Addendum: 2

Project: FWCS Fairfield Elementary School Restroom Renovations 2025

Addendum D2

re: **FORT WAYNE COMMUNITY SCHOOLS**
Fairfield Elementary School
Restroom Renovation 2025
 MPG No. 111029.00

A2.0

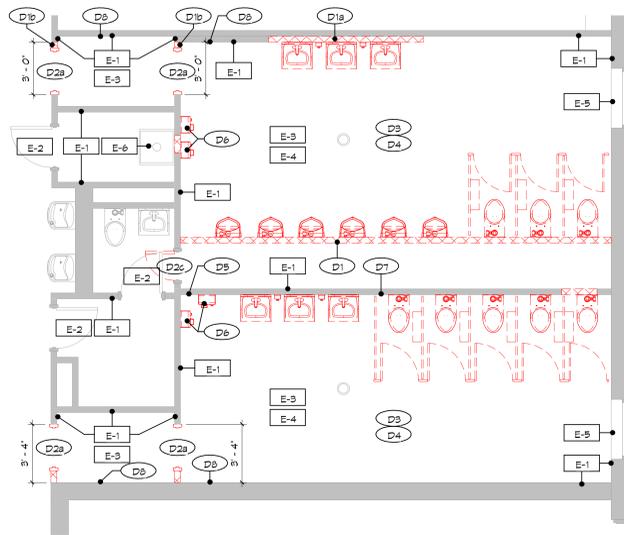
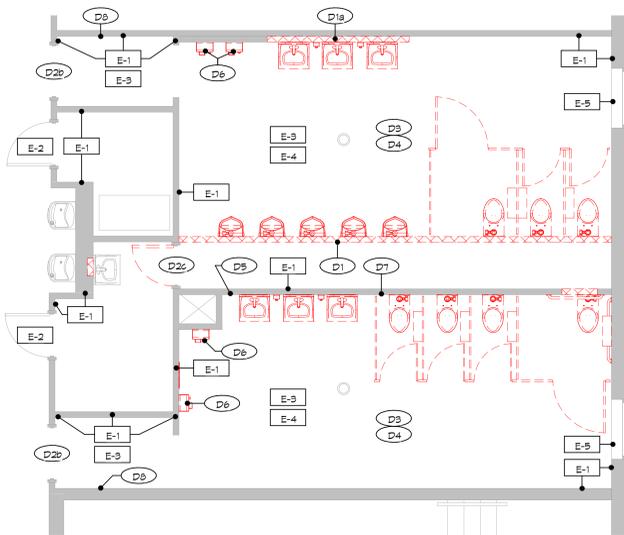
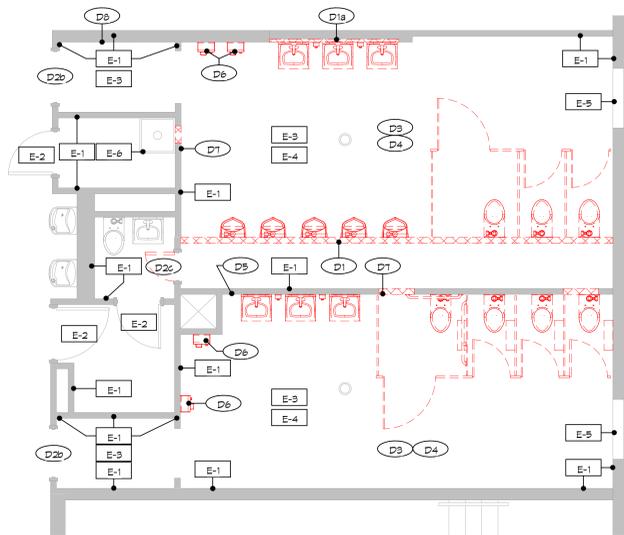
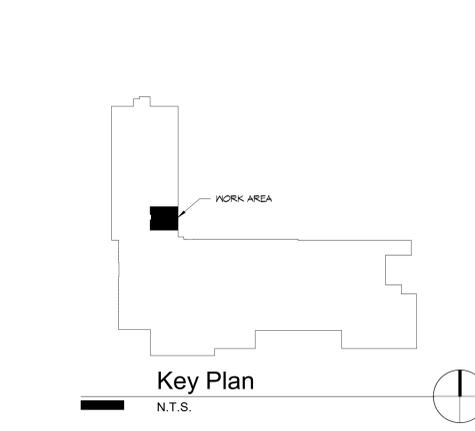
ITEM	LOCATION	DESCRIPTION
A2.01	SPECIFICATIONS Section 102113.19 Plastic Toilet Compartments	<u>DELETE:</u> Delete paragraph 2.3 A 4. b. (1) in its entirety. <i>The intent is that urinal screens will be provided by GC and installed as wall hung.</i>
A2.02	SPECIFICATIONS Section 102113.19 Plastic Toilet Compartments	<u>CHANGE:</u> Change 2.3 B 7 to read: Shoe type shall be stainless steel.
A2.03	DRAWING A2.0 (Drawing Reissued)	<u>ADD:</u> Reissue attached Sheet A2.0 Basement, First Floor, & Second Floor Demolition & Floor Plans reissued for clarifications or additions to scope.
A2.04	DRAWING A7.0 (Drawing Reissued)	<u>ADD:</u> Reissue attached Sheet A7.0 Room Finish Schedule, Legends, Finish & Equipment Plans reissued for clarifications or additions to scope.
